GROUP	MODEL
Safety Recall Campaign	2025MY EV9 (MVa)
NUMBER	DATE
SC337	February 2025

SAFETY RECALL CAMPAIGN

REAR MOTOR AND REDUCTION GEAR DRIVE ASSEMBLY REPLACEMENT (SC337)

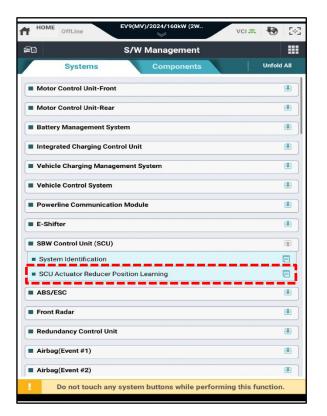
Note: The Shift by Wire (SBW) actuator assembly will need to be reused and transferred to the 'new' GDU/Rear Motor and Reduction Gear Assembly.

- 2a. Loosen the three (3) SBW actuator assembly(B) retaining bolts and remove it from the existing GDU.
- 2b. Install the removed SBW actuator assembly (B) onto the 'new' GDU.
- 3. Install the new GDU and all other removed parts in reverse order of removal.
